**RE: Echo Bay Mines Ltd., Lupin Gold Mine, Contwoyto Lake, NT.; Water Licence
NWB1LUP0008; 2002 Annual Geotechnical Inspection**

2002 GEOTECHNICAL INSPECTION OF PERIMETER TAILINGS DAMS

LUPIN MINE NUNAVUT

Re: 2002 Report on Annual Geotechnical Inspection
Perimeter Tailings Dams, Lupin Mine, Nunavut

Long Term Plot for Deep Nodes in D2-00-2
(Downstream side of crest of Dam 2, north end)

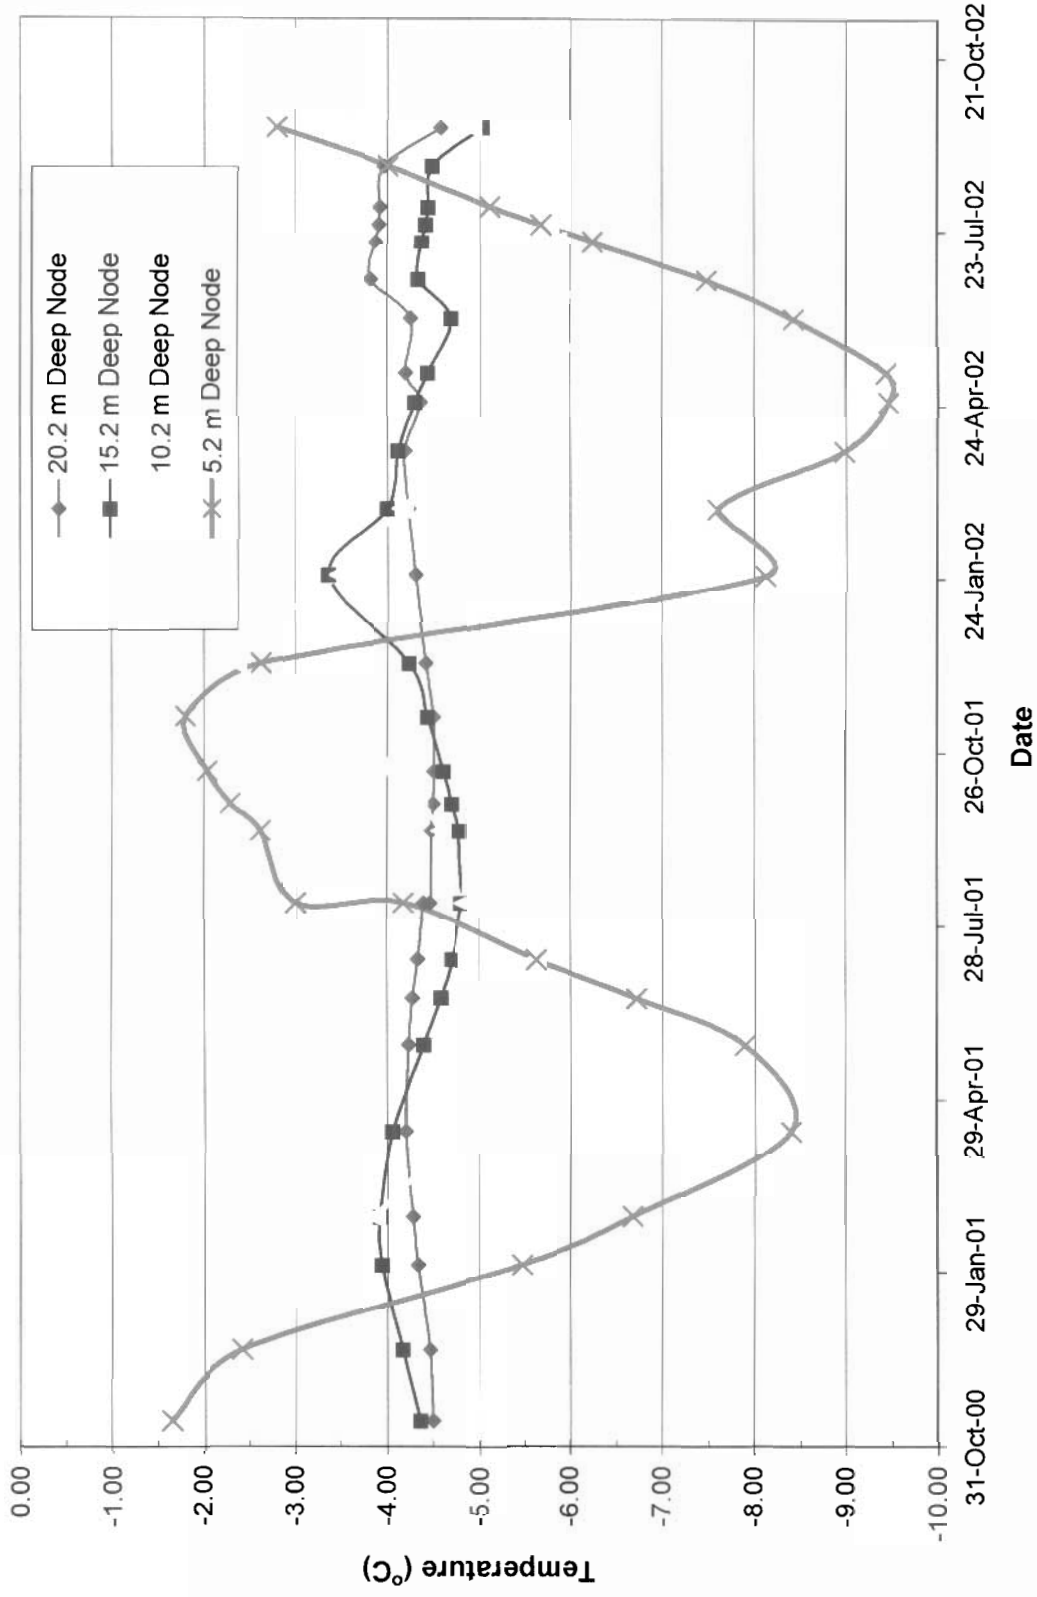
INSTRUMENTATION:	Thermistor D2-00-02 is located at the north end of the crest. Active layer depth was greater than 2.2 m in October 2001 and mid-September 2002. Temperatures at depth are subzero. Below 5 m depth (approximate bottom of embankment fill), temperatures are colder than -1.5°C . At depth, foundation zone appears to be cooling over the longer term.

**Long Term Plot for Deep Nodes on D2-00-3
(Crest of Dam 2, mid to north end of dam)**

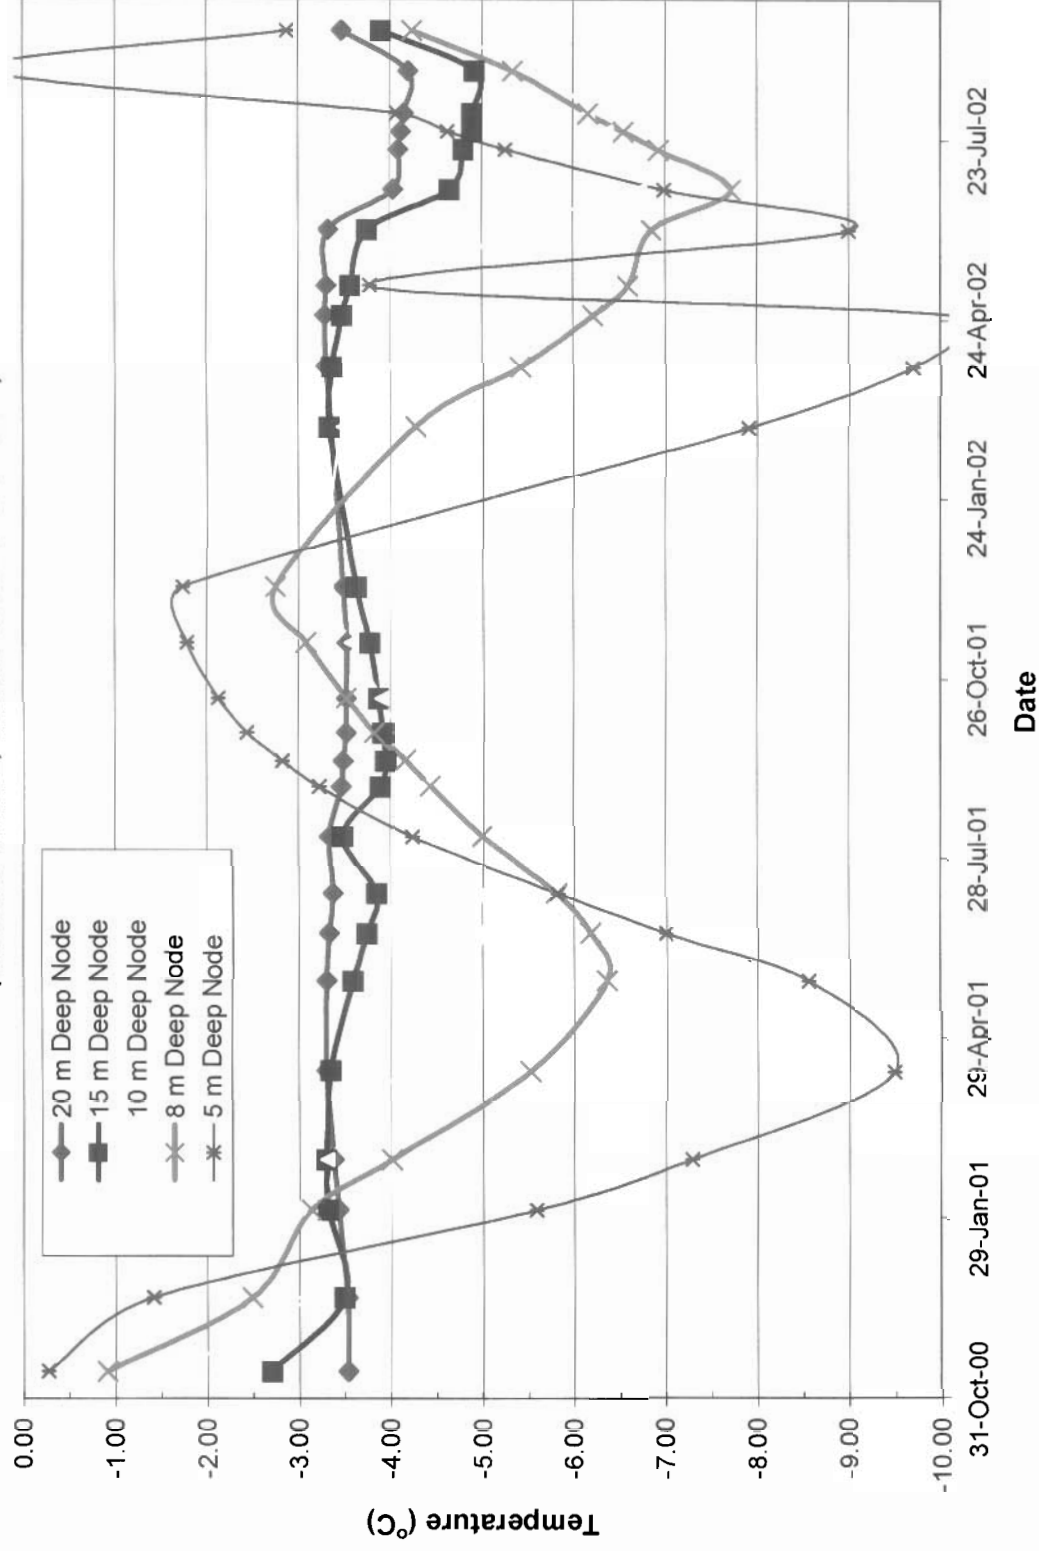
INSTRUMENTATION:	Thermistor D2-00-03 is situated near the mid-point of the dam. Active layer depths of greater than 2 m in October 2001 and 3 m in August 2002. One warm temperature reading recorded on August 26, 2002 at a depth of 5 m. Following reading after that warm reading was subzero again. Unsure if reading was an error or if some seepage at this depth may have occurred.
MAINTENANCE RECOMMENDATIONS:	Backfill one erosional gulley on the backslope, situated towards the north abutment. Monitor Thermistor D2-00-03 to ensure subzero conditions over the short term.
CONCLUSIONS:	The dam is in satisfactory condition. Continue with vigilant monitoring of instrumentation and visual condition assessment.

Long Term Plot for TD4-2
(Crest of Dam 4, East End, West of TD4-1)

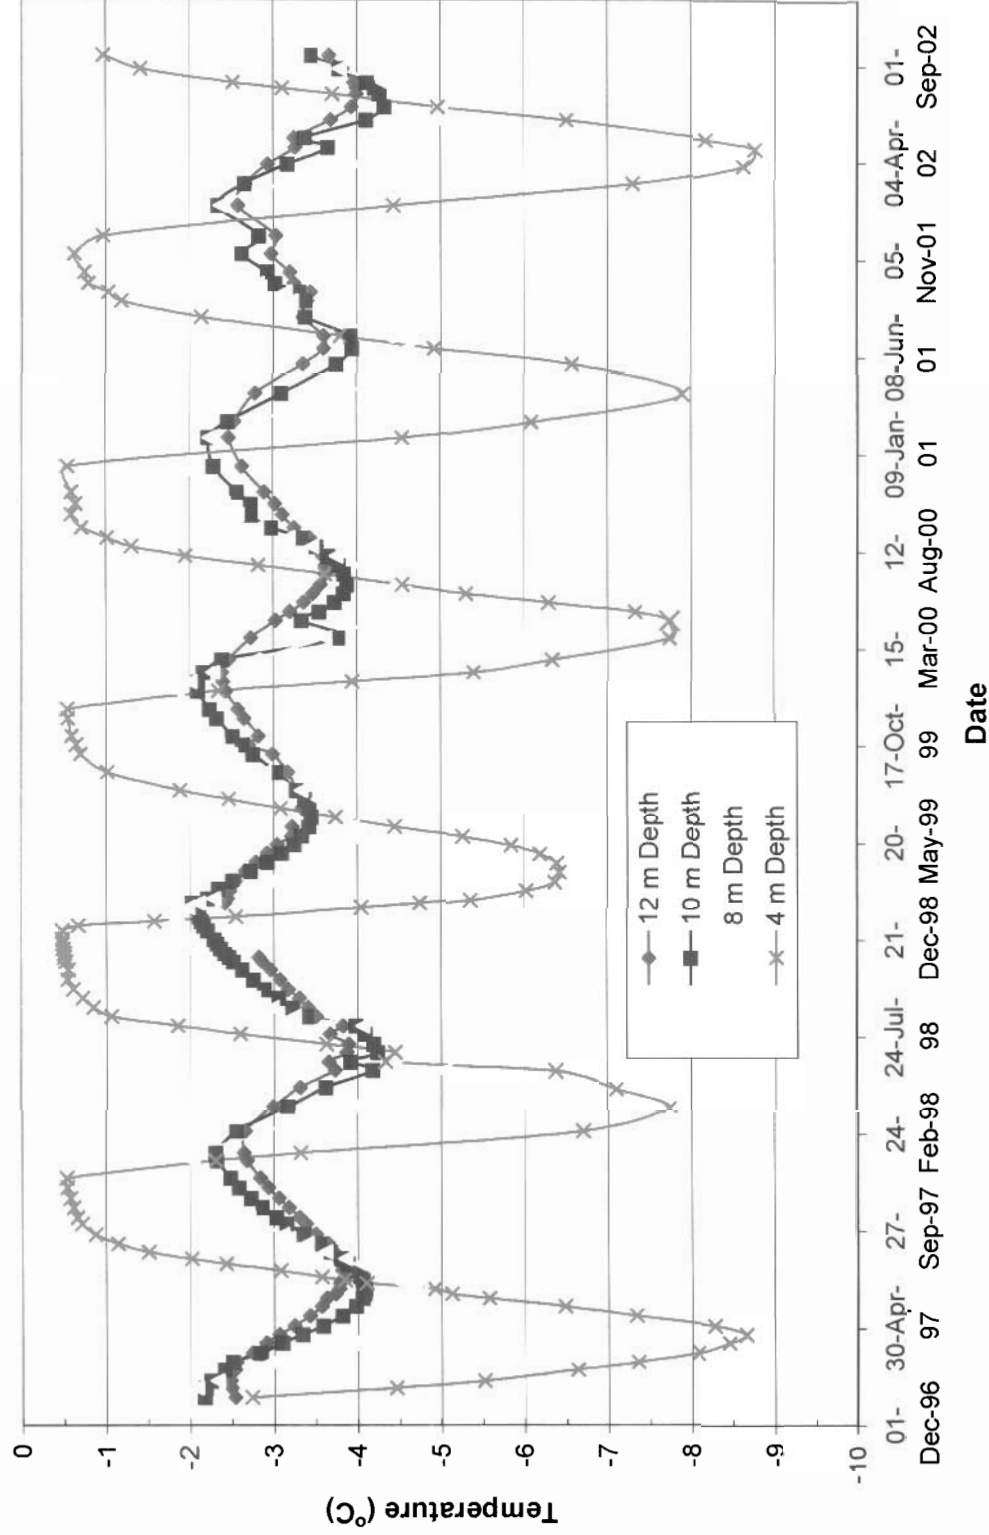
INSTRUMENTATION:	<p>Thermistor TD4-2 displayed just over 3 m of active layer thaw in October 2001 and just less than 3 m in mid-September 2002. Below a depth of 8 m, the subsurface temperatures have all been colder than -2°C and the subsurface points appear to be cooling over the longer term.</p> <p>Thermistor TD4-3 displayed over 2 m of active layer thaw in October 2001 and slight more thaw depth in mid-September 2002. Below a depth of 6 m (approximately embankment fill thickness), the subsurface temperatures have all been colder than -1.7°C with no signs of significant warming.</p> <p>Thermistor TD4-4 displayed just over 2 m of active layer thaw in October 2001 and slightly more thaw depth in mid-September 2002. Below a depth of 6 m (approximately embankment fill thickness), the subsurface temperatures have all been colder than -2.2°C with no signs of significant warming.</p>
MAINTENANCE RECOMMENDATIONS:	<p>Repair disturbed rip rap on the upstream side and investigate if underlying liner has been disturbed as well.</p>
